## **A Review of the Radiological Assessments Corporation's Fernald Dose Reconstruction Report**

Committee on an Assessment of CDC Radiation Studies, Commission on Life Sciences, National Research Council

RAC's draft report, *Task 6: Radiation Doses and Risk to Residents from FMPC Operations from 1951-1988*, was released in 2 volumes on August 22, 1996. Volume I summarizes the major releases of radionuclides, including releases to the atmosphere, surface water, and groundwater; discusses transport of radionuclides in air and in water; compares environmental measurements with predictions; and estimates the doses received by the public from FMPC releases, the health effects of the estimated doses, and the lifetime risks of cancer associated with each of 9 exposure scenarios. Volume II sets forth in technical detail the methods used in assessing doses and includes 20 appendixes that provide information on the data that were used, the analytic models and methods, and the assumptions inherent in the computations. The present report consists of the committee's review and assessment of those volumes.

Figure 1. A proposed flowsheet to illustrate the fundamental differences between the two methods of estimating radon releases.

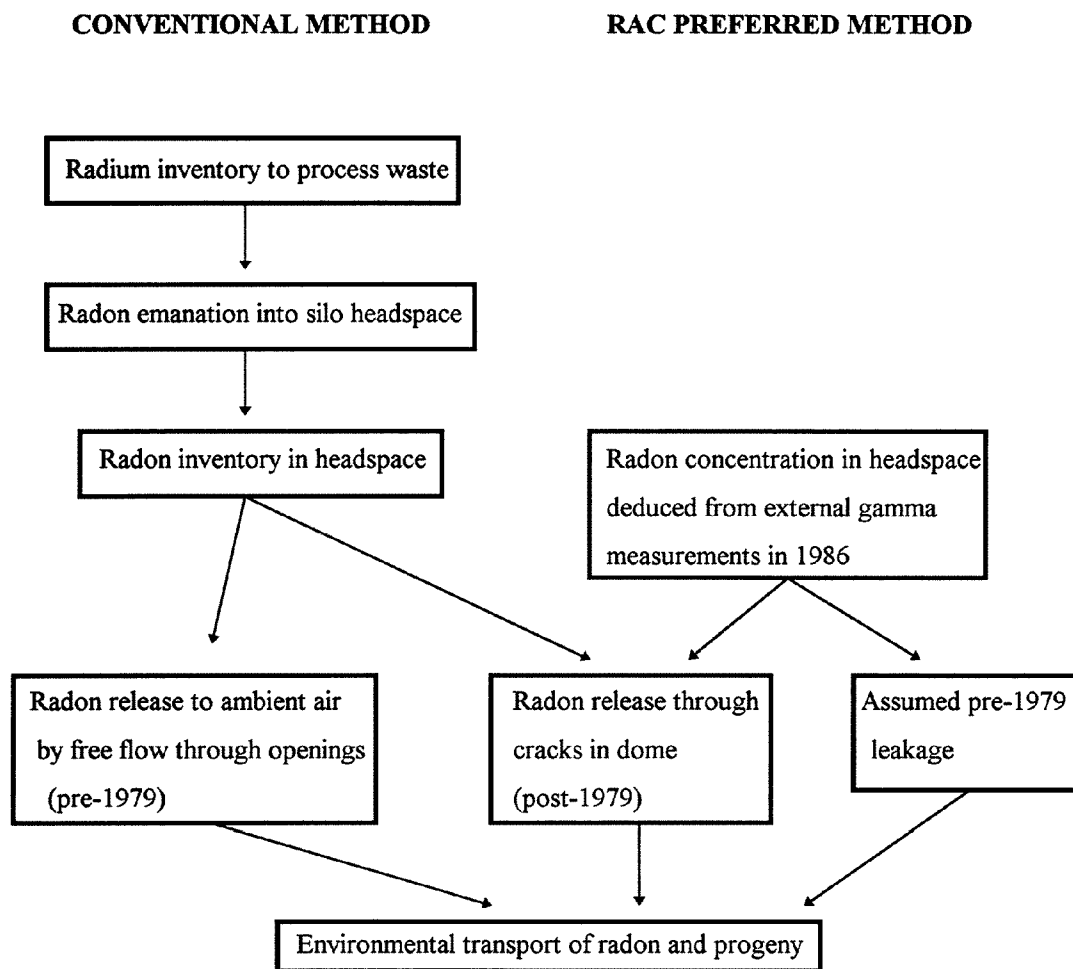
A better flowsheet for the 2 methods might look like the illustration in [figure 1](#) on the next page. The 2 methods differ essentially in how the original radon source term is obtained. They use the same assumptions regarding escape to the outside air before and after the 1979 sealing of major openings in the silos, and both assume that diurnal warming of the headspace is the principal driving force to radon release.
